METROPOLITAN COAL LONGWALLS 311-316

EXTRACTION PLAN

Title Metropolitan Coal Longwalls 311-316 Extraction Plan

Document Reference Number EP-R01-E

Figure 1: Reproduction of Figure 1 of the Dupen Report in which it is captioned as *Key features discussed in this report, annotated in green over base figure reproduced from Metropolitan Coal 2021 Annual Report,* with the blue text boxes being added by the Panel.

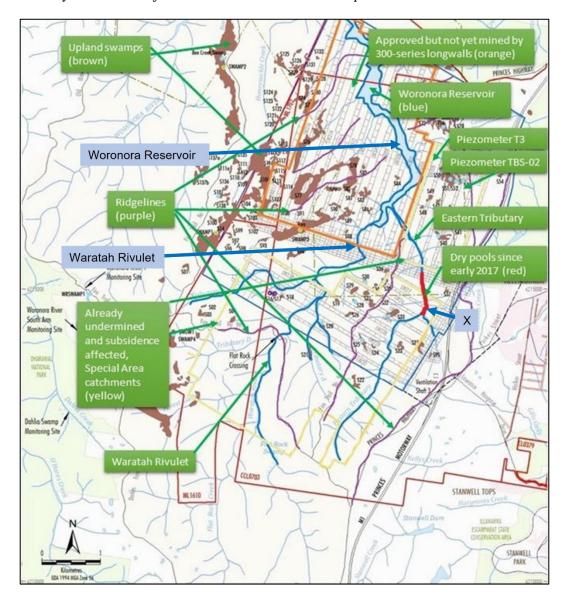
This 500 m section of the Eastern Tributary is the section that has been marked in 'red' by Dupen in Figure 1.

The IEPMC also produced three advice reports for DPE regarding the Extraction Plans for LW303, LW304 and LW305 to LW307, respectively. These reports were concerned with limiting further impacts of valley closure on the lower reaches of the Eastern Tributary, including part of the area of particular concern to Dupen shown in red in Figure 1.

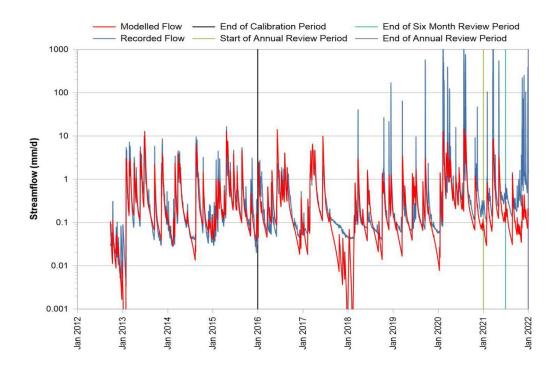
The Dupen Hypothesis¹ has its primary basis in Figure 3, which is Chart 3 of the Metropolitan Coal 2021 Annual Review (Peabody, 2022b). Dupen has concluded on the basis of this chart that during the reporting period (1/1/21 to 31/12/21), flow in Eastern Tributary has been increasingly higher than model predictions ².

are prone to errors especially at high flows: the flume is designed to accurately measure flows up to approximately 235 L/s (3.5 mm/day in Figure 3) (HEC, 2022). Any flows above this value are estimated using a rating curve (a curve showing the relationship between water level and stream flow rate), which has been approximately estimated and lacks validation (HEC, 2022). The Panel's field inspection on 10 May 2023 noted that the concrete weir stops short of the bank, which may contribute to errors at low to medium flow rates due to water escaping around the flume and weir.

Figure 4: Piezometric data for Boreholes T1 to T6 extending from the reservoir along a transect approximately at right angles to the reservoir. (Reproduction of Figure 9 in the Dupen Report)³

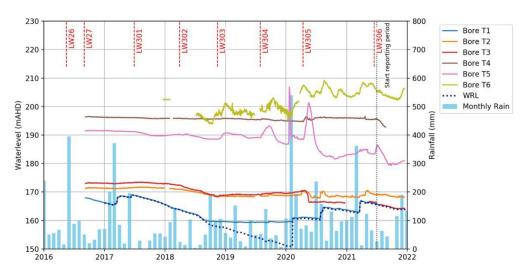
There are numerous concerning aspects of the post-mining groundwater conditions revealed by the transect piezometers. These include the long-term anomalously low water table in T5 (Figure 8 and Figure 9) and recent drops in T4 and T5 levels. Another surprising feature are the three large (+10 m) observed level surges in T5 between mid-2019 and mid-2020 (Figure 9), which are reasonably attributed by Peabody's consultants to pressure waves affecting the aquifer as the longwalls progress beneath. If present however, any pressure waves felt at T5 should intuitively have been observed at all of the nearby wells, especially the adjacent T4 piezometer (Figure 3). The reason for this contrast in pressure wave response through the

The most disturbing trend however, is that the levels in T3 dropped below its base 17 days after the commencement of Longwall 305 (Figure 3), and then sheared in December 2020 (Figure 9). The piezometer was replaced in 2021 by a deeper one at the same location (T3-R). As can be observed by the red trace in Figure 9, groundwater responses in T3/T3-R appeared sensible for its ridge position prior to mining but now the water table closely mimics the reservoir level.

Figure 6. Reproduction of Figure 4 of the Dupen Report where it is described as *Schematic* showing the hypothesised causes of "ridge fracture drainage", annotated here as basal shear planes (yellow) and sub-vertical stress relief fractures (grey). Base figure reproduced from Advisian, 2016

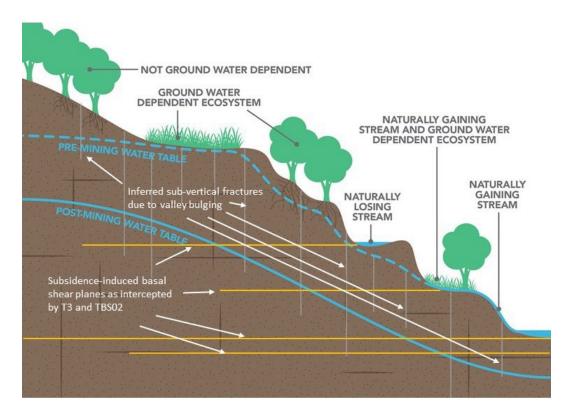
2. Whilst some non-conventional valley closure effects may well have contributed, the primary cause of flow diversion is the impositions of a mechanism termed here as "ridge fracture drainage" (Figure 4)6; the opening of widespread and interconnected basal shear planes beneath the base of the valley between Pools ETAG to $ETAR^7$, combined with sub-vertical drainage along and below the ridge surfaces. If these subsidence effects are indeed substantial, ridge fracture

drainage presents a risk to the catchments that has not previously been recognised, and the implications for future longwalls should be urgently reconsidered.

Figure 9: Profiles of predicted valley closure along the Eastern Tributary associated with both the mine layout proposed in the EIS for the Metropolitan Coal Project and the modified layout presented to the PAC during its assessment process (Peabody, 2009).

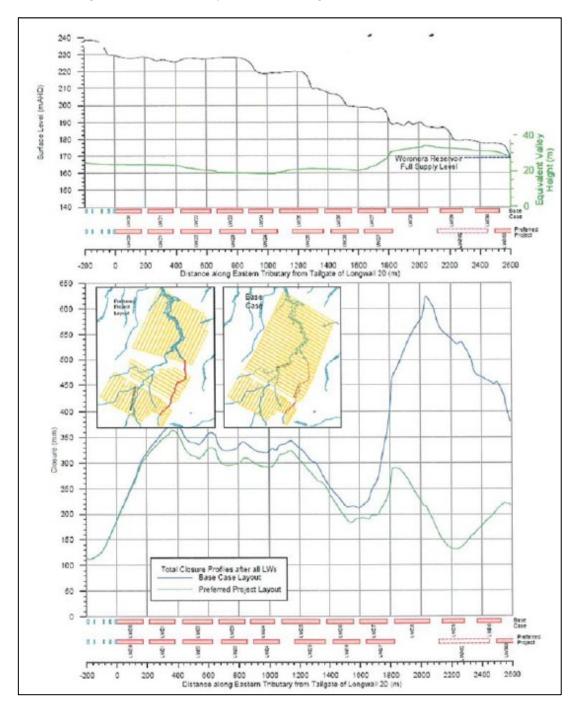
The revised mine layout was based on limiting predicted valley closure along Waratah Rivulet to less than 200 mm. However, this in turn did result in a reduction in predicted valley closure along the Eastern Tributary, as shown in Figure 9.

An expanded version of the PPR was submitted to the Department of Planning (DoP) after the PAC had concluded its review (as reported in the Department's 'Reasons for Approval'). However, the mine plan and predictions of valley closure were basically unchanged from that shown in Figure 9. DoP stated in its assessment of the PPR that:

LW27 was completed in March 2017 and mining of LW301 commenced in June 2017. This panel was shortened for operational reasons and, as shown in Figure 10, stopped over 350 m short of its planned finish point. Hence, the contribution of this panel to cumulative valley closure along the Eastern Tributary could be expected to be minimal. LW302 was extracted to its originally planned and finished in February 2018. Soon after, it was recognised that the Performance Measure of negligible for 70% of the length of Eastern Tributary downstream of Point X had been exceeded, resulting in LW303 to LW305 being setback from Eastern Tributary substantially greater distances than planned at the time of project approval. The modified layout, shown in Figure 10, resulted in moderate to very large decreases in predicted valley closure downstream of about pool ETAM²⁵, as evidenced by comparing predictions plotted (in green) in Figure 9 with those tabulated in Figure 10.

Figure 10: Predicted cumulative valley closure at the Eastern Tributary for LW302 to LW308 (Peabody, 2019).

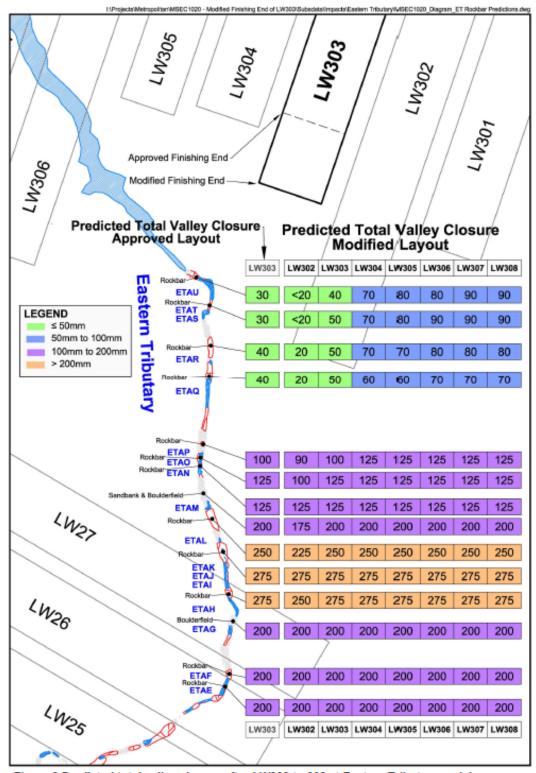
Nevertheless, although the actual mine layout was predicted to result in valley closure of only 125 mm at rockbar ETAO, it appears that subsidence effects were sufficient to cause subsurface flow at this rockbar. Figure 11 shows the appearance of 10 m of core recovered to one side of Rockbar ETAO. This photograph was taken during the Panel's site inspection on 20 May 2023. Drilling was in progress and the core had still to be geotechnically logged. However, the photograph clearly shows a high density of iron-stained fractures, especially in the upper 5 m of the core. No information was available at the time on the in-situ aperture of these fracture planes and how fracture density and aperture compared with that towards the centre of the watercourse. Grouting was also in progress to remediate the fracture network at the rock bar. Field observations and discussions with operators made a compelling case that subsurface flow is occurring at this location.

Figure 3: The mine layout for LWs 311 to 316 (MSEC, 2024b), noting that it does not capture changes made to the finish points of LW 312 and LW 313 and the starting point of LW 313.

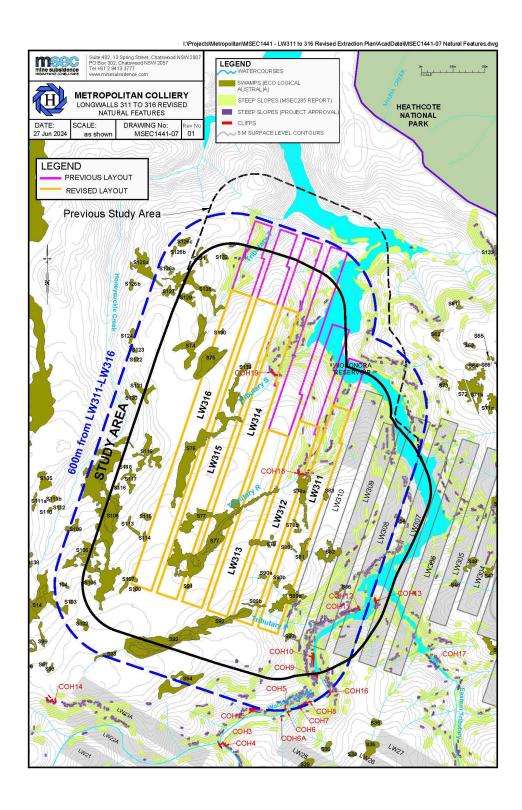
Figure 3 shows two mining layouts referred to in EP documentation as the 'Previous Layout' and as the 'Revised Layout'. It does not capture the latest revisions to LW 312 and LW 313 shown in Figure 2. The figure shows Swamps 76, 77 and 92 and their associated tributaries S, R and P, respectively, which are focal points in this chapter.

The most recent revisions to the starting and/or finishing ends of LW 312 and LW 313 are not shown but these result in nil to negligible change in the valley closure predictions shown for the revised layout.
